**CONWAY**  
HISTORIC DISTRICT COMMISSION  
STAFF REPORT

**5:30pm • June 25, 2018 • City Hall**

**ROBINSON HISTORIC DISTRICT  
CERTIFICATE OF APPROPRIATENESS REVIEW  
REMODEL TO SINGLE-FAMILY RESIDENCES  
1618/1620 & 1622/1624 ROBINSON AVENUE**

Site Plan

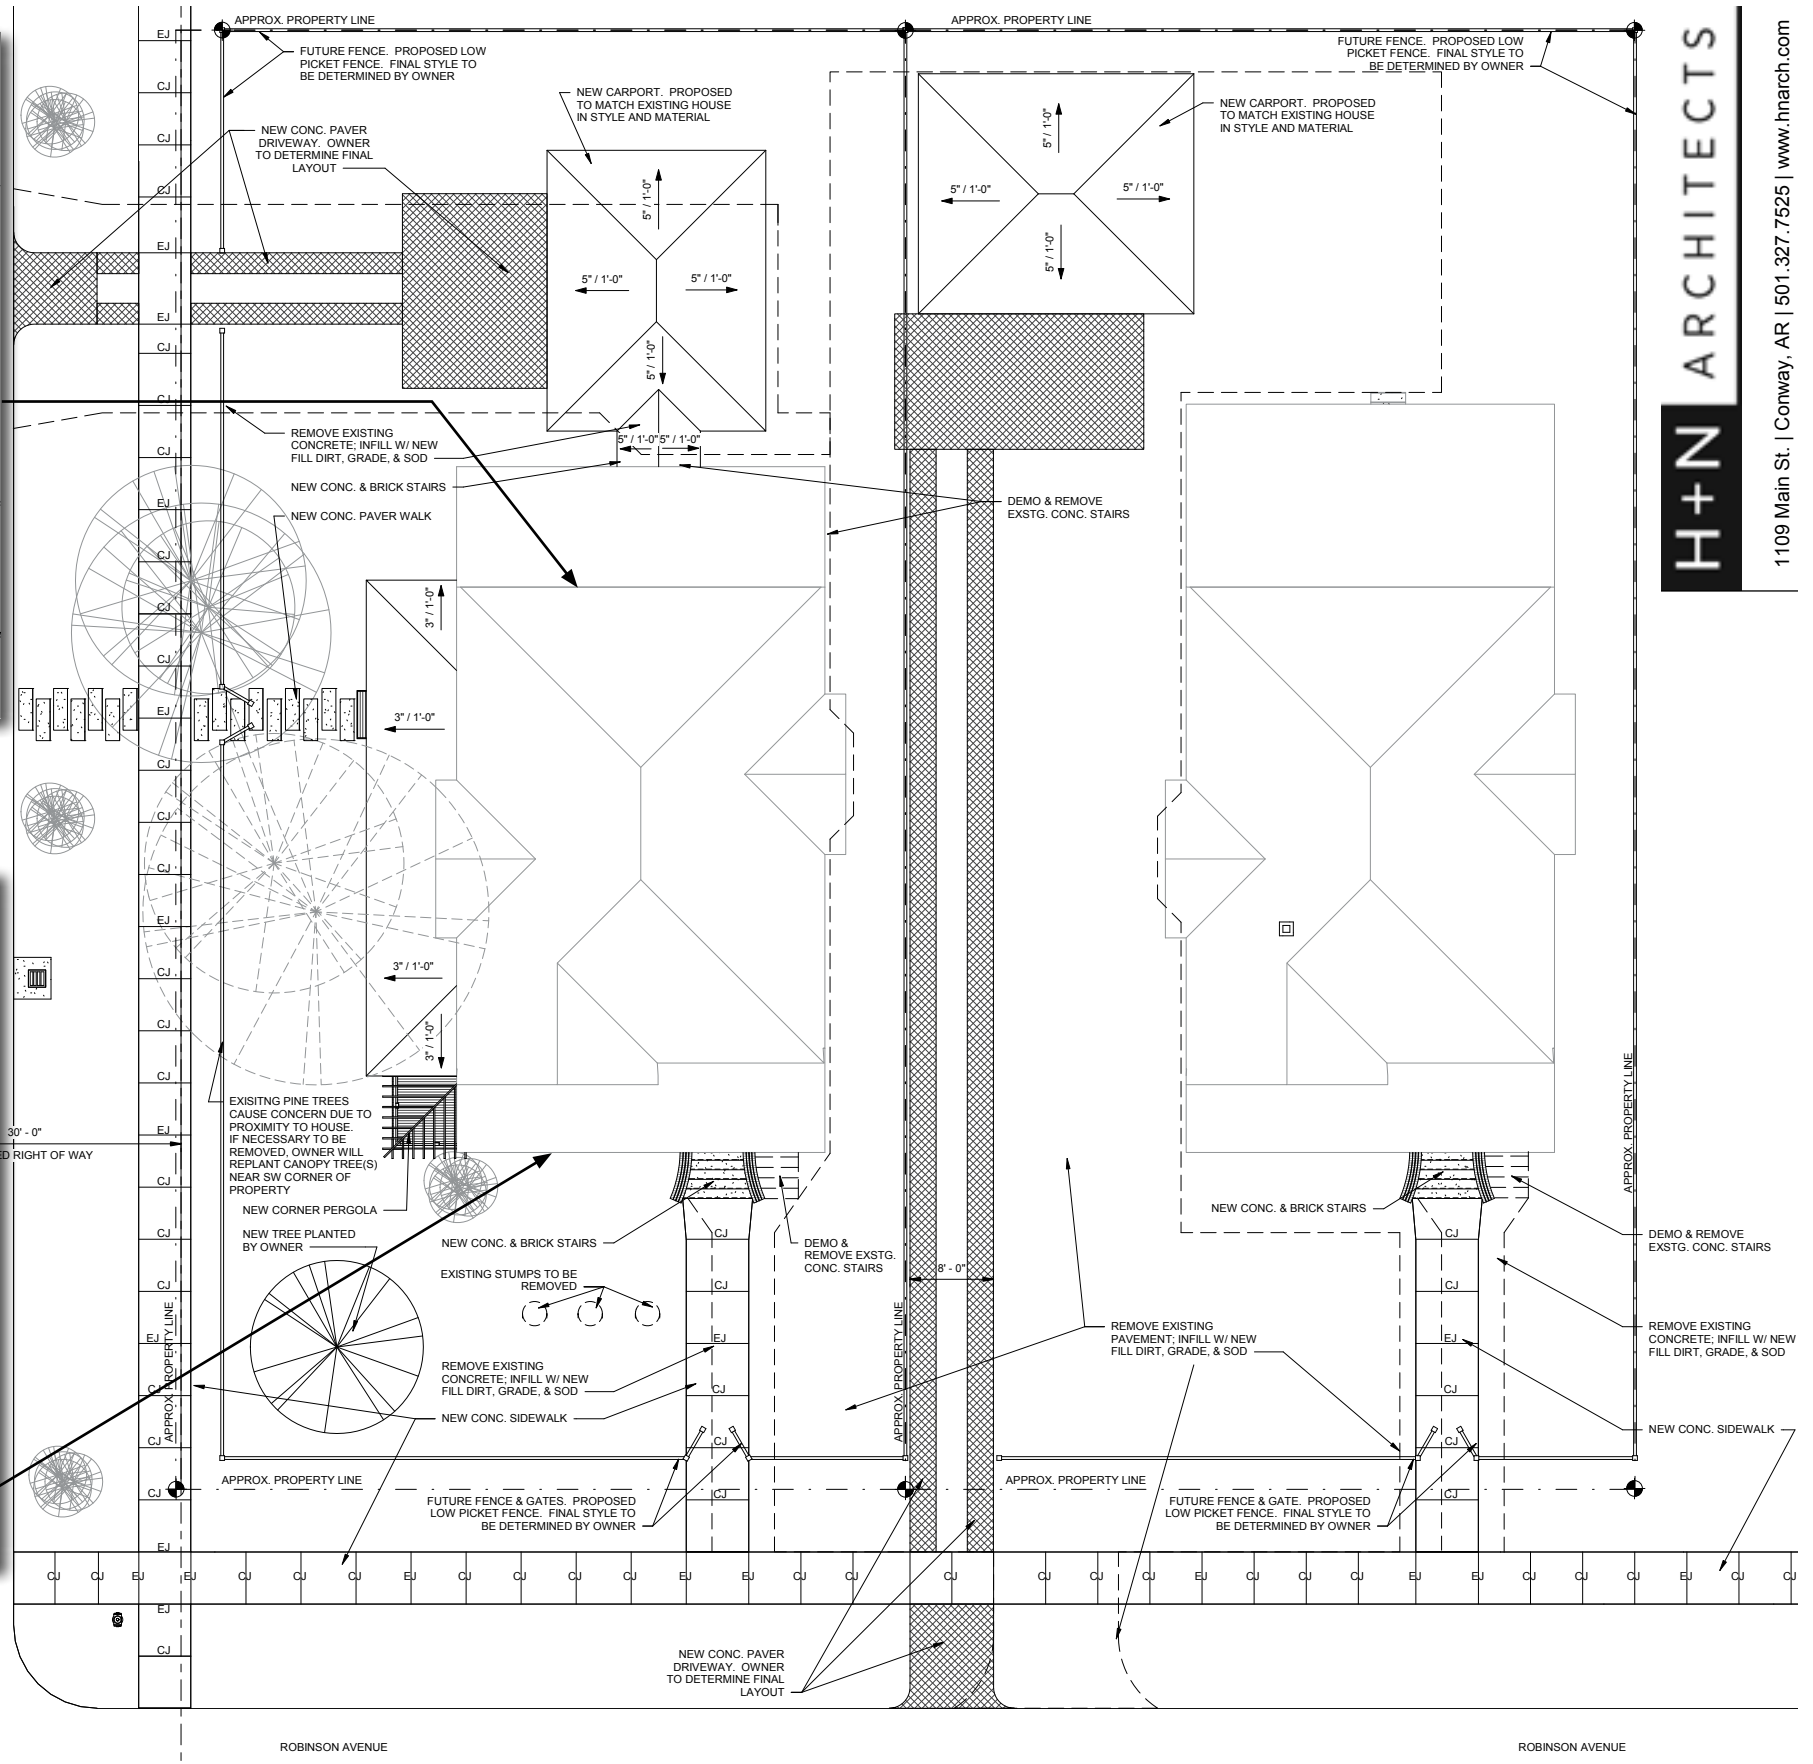
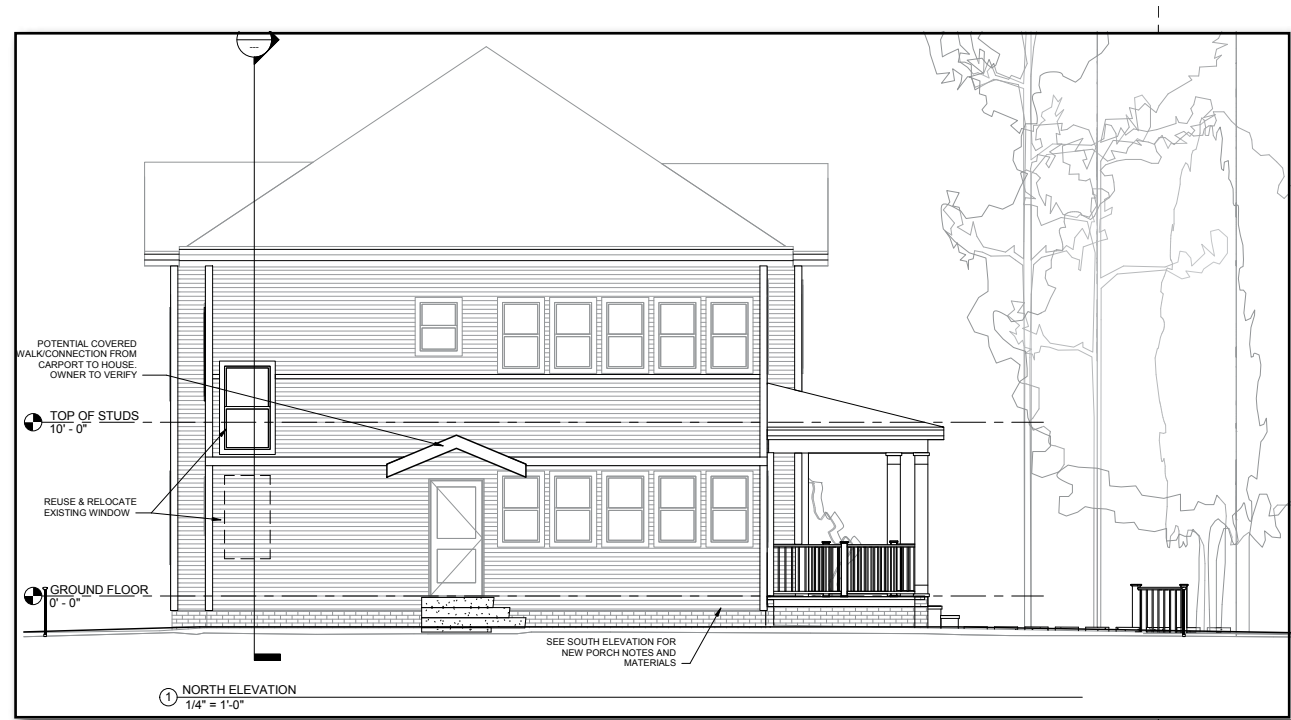
The proposed site plan shows crepe myrtles surrounding the parking area. Crepes can be used but would be in addition to the required screening hedge.

Overall, the porch addition, new construction, and remodeling of the residence(s) appear to be appropriate. However, these changes must be filtered through the Robinson District Guidelines. The proposed reconstruction of sidewalks, tree removal/remediation, picket fence, driveways, carport design and locations, appear to generally meet the guidelines.

1. The new porch on the west residence, new carport(s), new driveway(s), renovations, and remodeling shall be constructed and completed as shown on the submitted plans.

3. Replacement siding shall be wooden with matching profile.
4. A picket fence meeting the Robinson Guidelines section 2.2.2 may be constructed.
5. Pine trees on the west side of the west residence may be removed. If removed, a canopy tree shall be planted in the southwest corner of the property at 1624 Robinson.

1618/1620 & 1622/1624 Robinson Ave - South Elevations

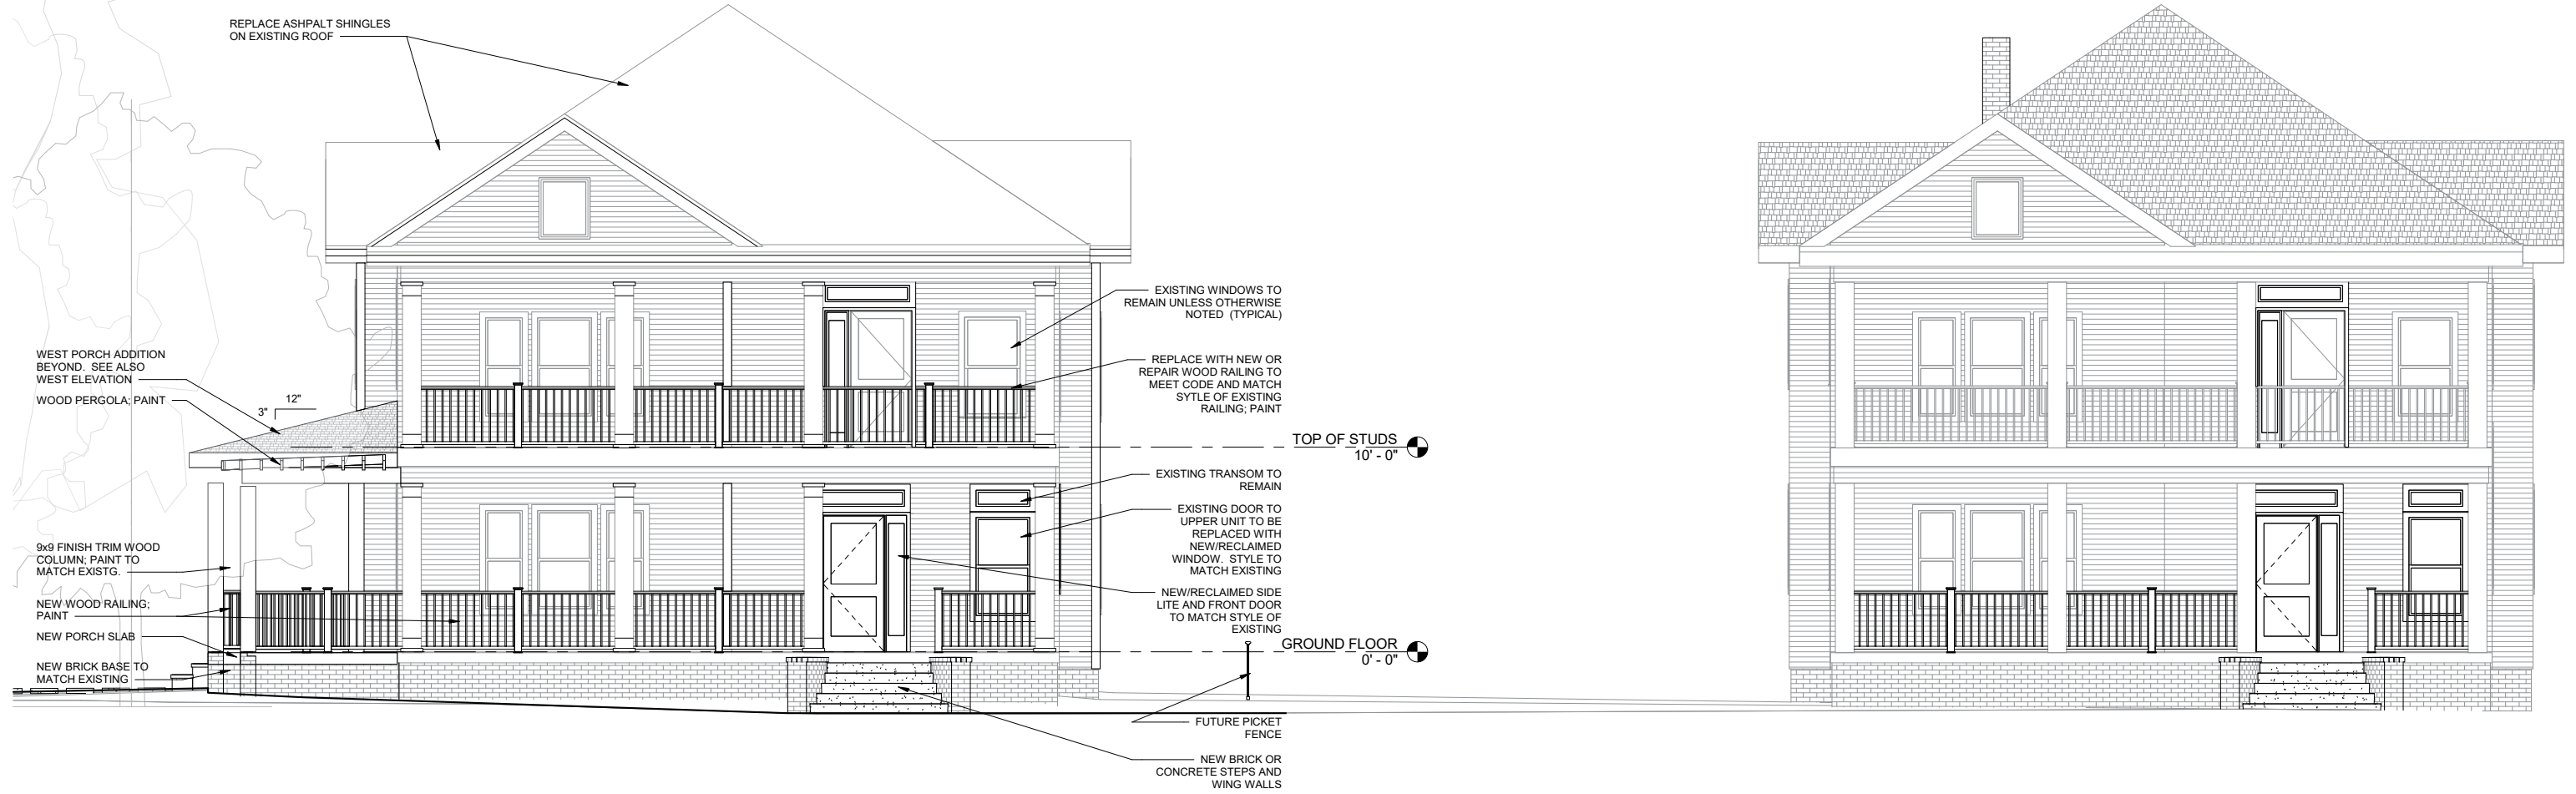
Front Facades. One of the bigger changes in light of the guidelines is the front facades. Guideline 2.5.2 states that the front elevation should have the greatest scrutiny. A front stair access door is proposed to be removed and replaced with a window (the transom will be retained). The ground floor front door and upstairs porch doors are to be removed and replaced with half glazed doors (transoms will be retained). New porch railing is planned for the ground floor porch. New concrete steps and brick wing walls are proposed. From a preservation standpoint, existing doors and windows are original features. From a design standpoint, these changes would create a better defined and grander entry. The removal of the exterior stair

Site Plan

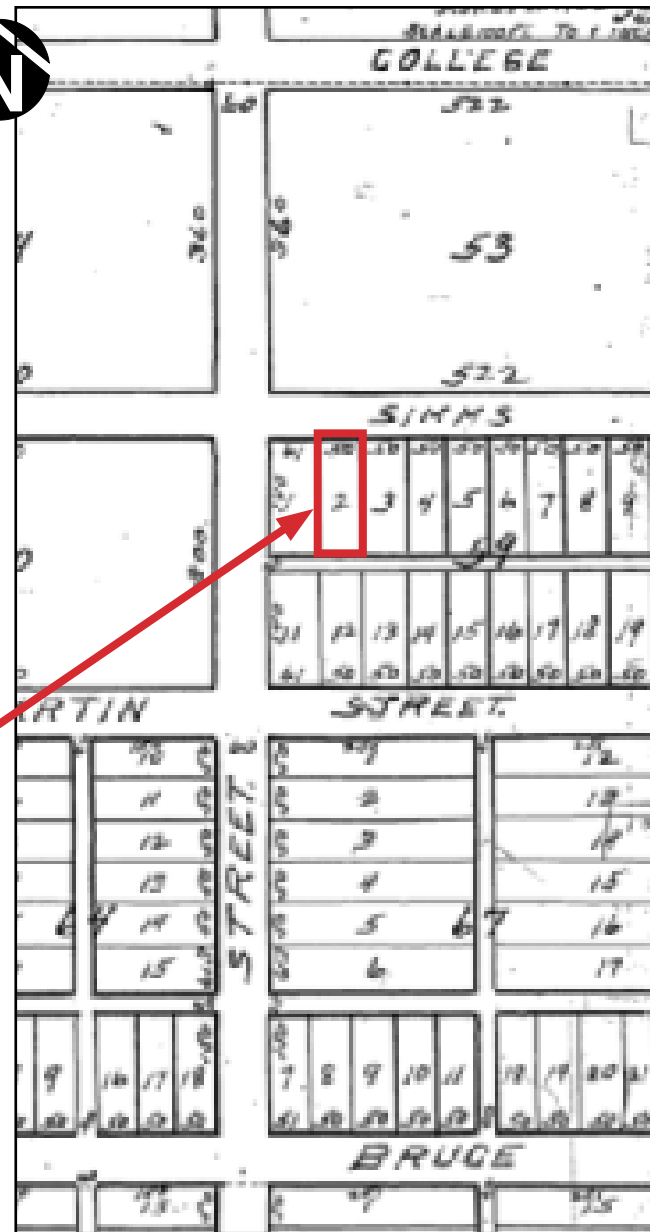
**Driveway/Parking/Carport.** The proposed lot is vacant property with no existing driveway. No driveway is shown on the submitted site plan. There is approximately 40 feet of depth between the curb and proposed front porch. Additional information concerning the driveway can be obtained from the applicant at the meeting.

1. The residence shall be constructed as shown in submitted plans.
2. Driveway shall be concrete with a maximum width of X? feet.
3. The residence’s front setback shall be approximately 25 feet from the property line.
4. Porch shall be 6 foot minimum in depth. Porch columns shall be a trimmed out to approximately 8 inches by 8 inches.
5. Floor to ceiling height shall be 9 foot minimum.
6. Siding material shall be fiber cement board or similar.
7. Wide trim around windows and doors shall be used.
8. One additional window shall be placed in the front master bedroom’s west wall.
9. One over one windows shall be used.
10. HVAC and utility equipment shall be appropriately located at the rear or side of the structure and/or appropriately screened.
11. A new sidewalk shall be constructed along Weems Street or an in-lieu fee of (\$X) shall be paid prior to issuance of a Certificate of Occupancy.

Front (North) elevation

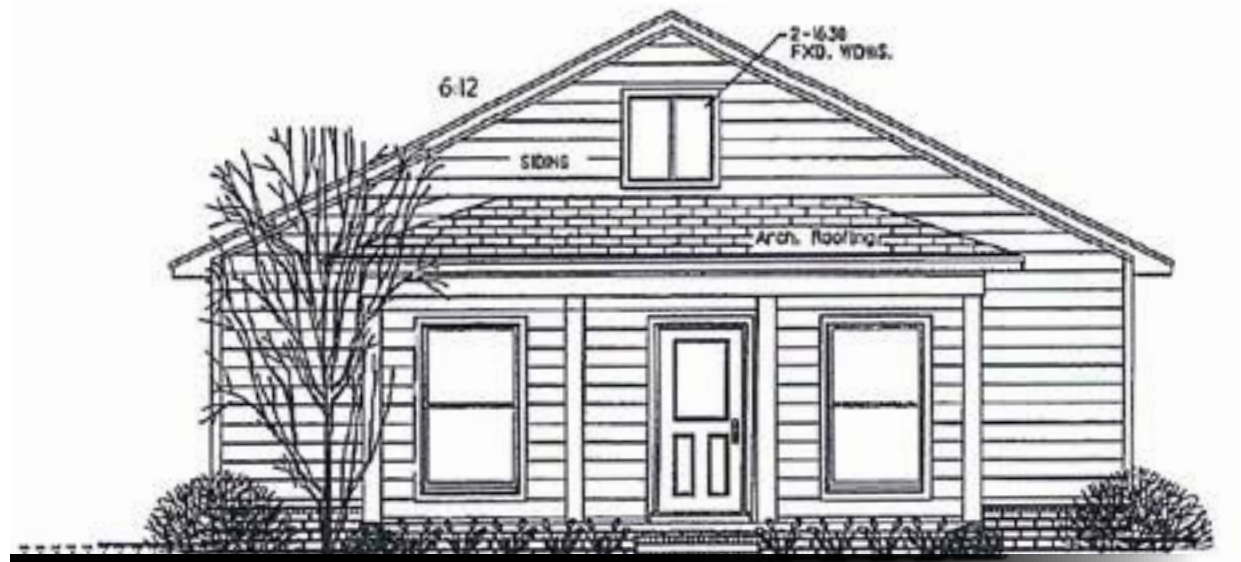
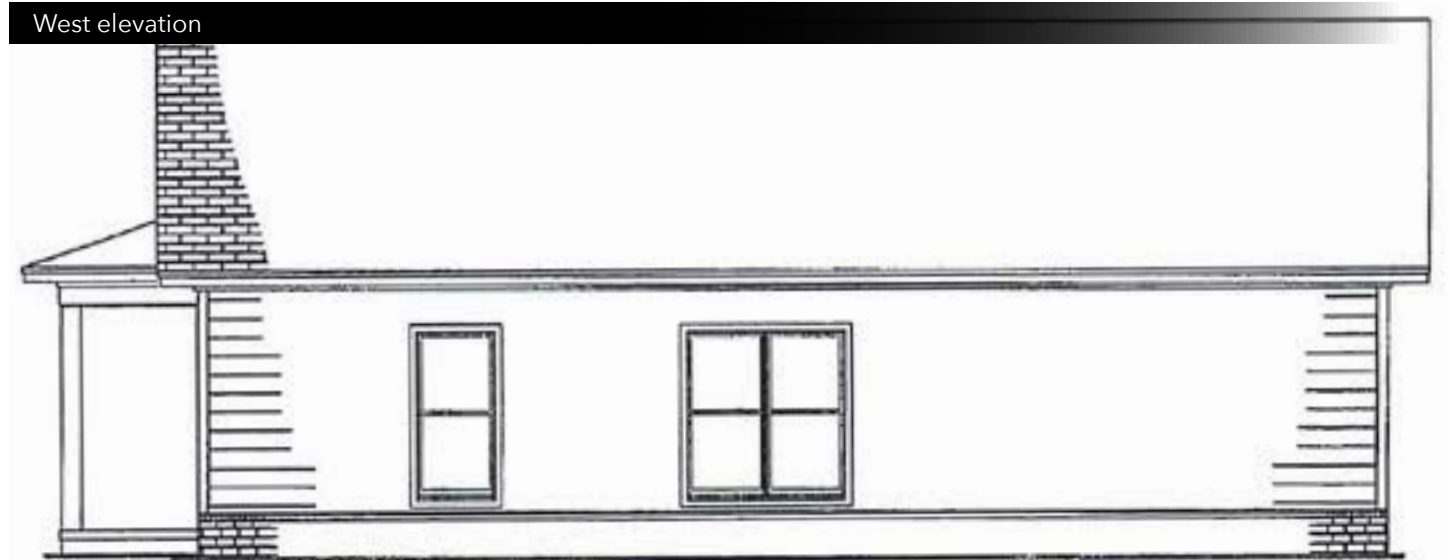
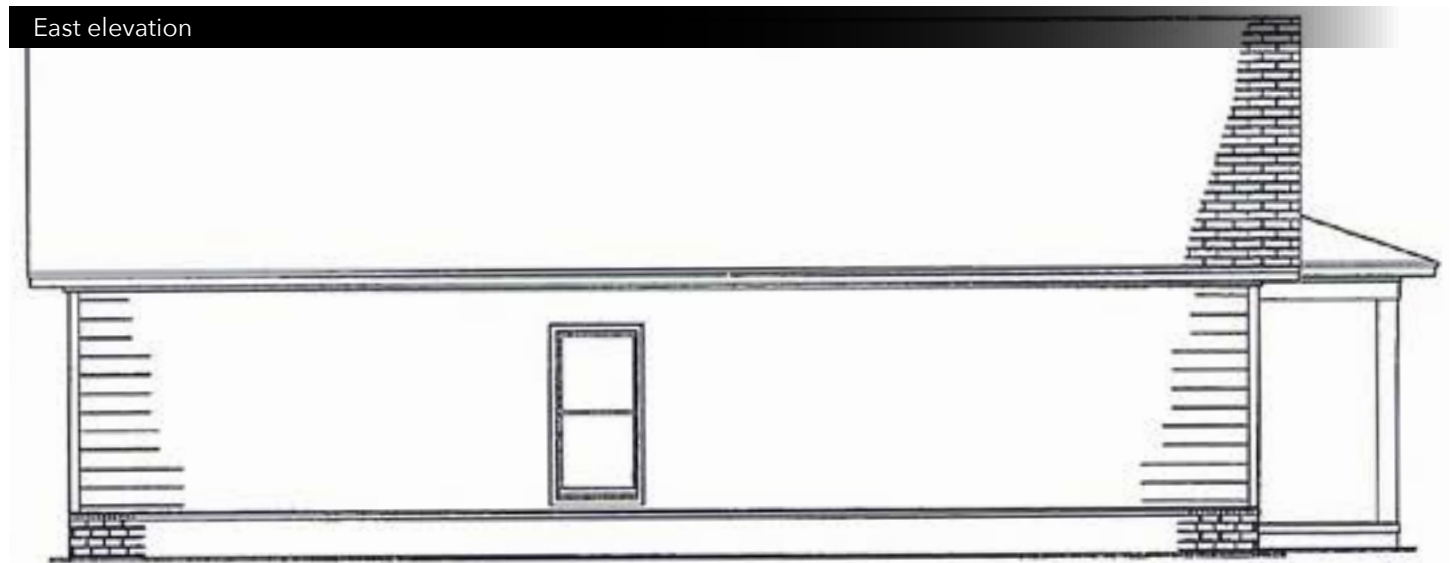
**Height.** The average height of area structure’s eaves and cornices. Also, the first floor elevation / height relationship. The overall height and eave lines are appropriate. The first floor height should be minimally 9 feet floor to ceiling. A note on the floor plan states that ceilings are to be 9 feet in height.

**Complexity of form.** The level of detailing and breaks in wall planes of a structure. The residence a minimal amount of detailing. The residence’s front wall plane is broken by a hip roofed porch. A brick foundation wall is shown around the home’s perimeter. Other area homes have minimal detailing. The proposed residence’s detailing should blend with area structures.
